UNITED STATES PATENT AND TRADEMARK OFFICE

10/797,449

Office Action Summary	Application No. 10/797,449	Applicant(s) OSBORNE ET AL.	
	Examiner Cheryl Miller	Art Unit 3738

DETAILED ACTION

FIG. 9

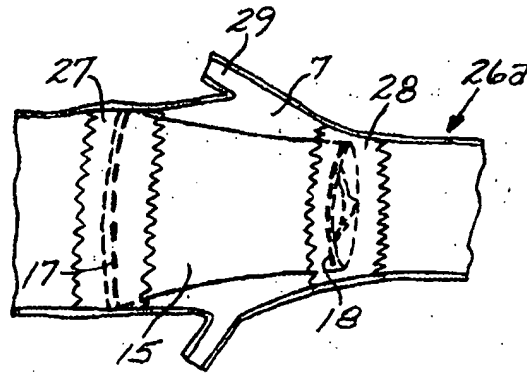
Claims 1-4, 7-9, and 13 are rejected under 35 U.S.C. 102(e) as being anticipated by Duran et al. (US 7,125,418 B2). Duran discloses a medical device (fig.6, 8, 11A, 11B) comprising a radially expandable support frame (stent 27+28+23; OR 17+18+23), at least one leaflet (located between commissures 20 in figs.) having a first edge (bottom inflow edge) attached to the support frame (at 17) and a second edge (top outflow edge) free from the frame (at 20a), the leaflet movable from a first position (seen open in figs.7a, 8b, 9) permitting flow in a first direction and a second position (seen in figs.11a, 8c) substantially preventing flow in a second direction, a portion of the frame (28) and second edge (20a) cooperatively defining an opening (seen in figs.11a, 9) that permits a controlled amount of flow in the second direction (see

attachment 1). Duran discloses the frame to be same expanding Ni-Ti (col.5, lines 105, 64-68), and the leaflet to be bioremodelable (col.3, lines 36-42, 58-61). Duran discloses the leaflet attaching to the frame by a suture (17, 18), the device comprising two leaflets (see figs) and the opening to cover less area than the total vessel cross section (seen in fig. 11a).

FIG. 11A

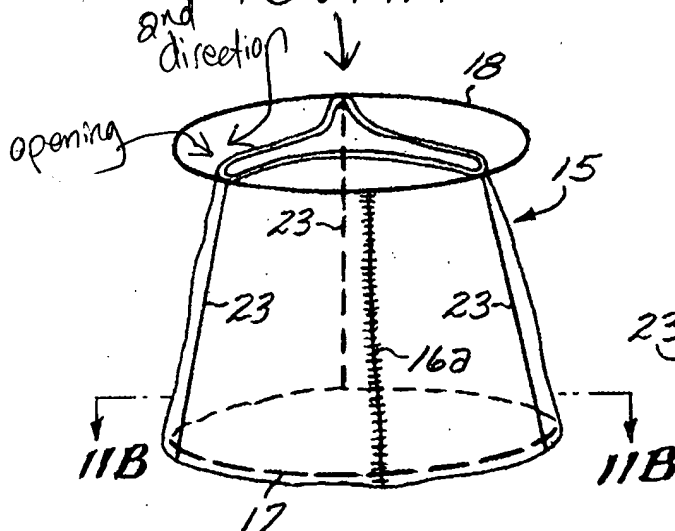
Referring to claims 10 and 11, Duran has shown an opening formed between the frame and leaflet edge when in the closed position, opening only a portion of the vessel cross-section (see fig. 11a for example), however is silent to mention an exact percentage of openage. It would have been obvious to one having ordinary skill in the art at the time the invention was made to have the percent open area claimed, since such a modification would have involved a mere change in the size of a component. A change in size is generally recognized as being within the level of ordinary skill in the art. *In re Rose*, 105 USPQ 237 (CCPA 1955).

FIG. 1

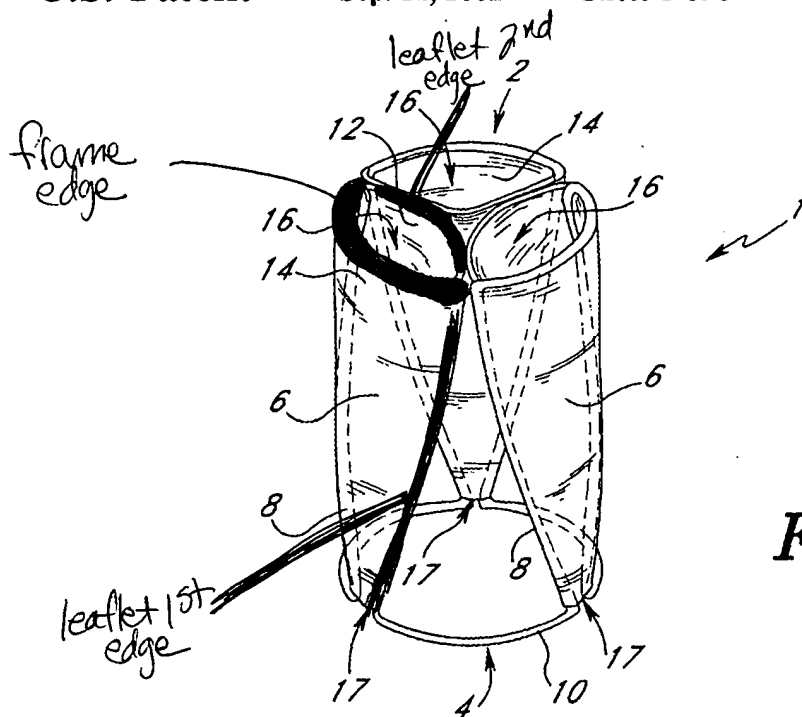
Claims 3-6, 10, 11, and 13-15 are rejected under 35 U.S.C. 103(a) as being unpatentable over Moll et al. (US 6,287,334 B1). Referring to claims 3-6 and 13-15, Moll discloses a medical device (fig.1) having all the structural features claimed (see above), however does not disclose the exact materials claimed for the frame and leaflet. It would have been obvious to one having ordinary skill in the art at the time the invention was made to have the claimed materials for the leaflets and frame, since it has been held to be within the general skill of a worker in the art to

Referring to claims 10 and 11, Moll has shown an opening formed between the frame and leaflet edge when in the closed position, opening only a portion of the vessel cross-section (16; fig.1), however is silent to mention an exact percentage of openage. It would have been obvious to one having ordinary skill in the art at the time the invention was made to have the percent open area claimed, since such a modification would have involved a mere change in the size of a component. A change in size is generally recognized as being within the level of ordinary skill in the art. *In re Rose*, 105 USPQ 237 (CCPA 1955).
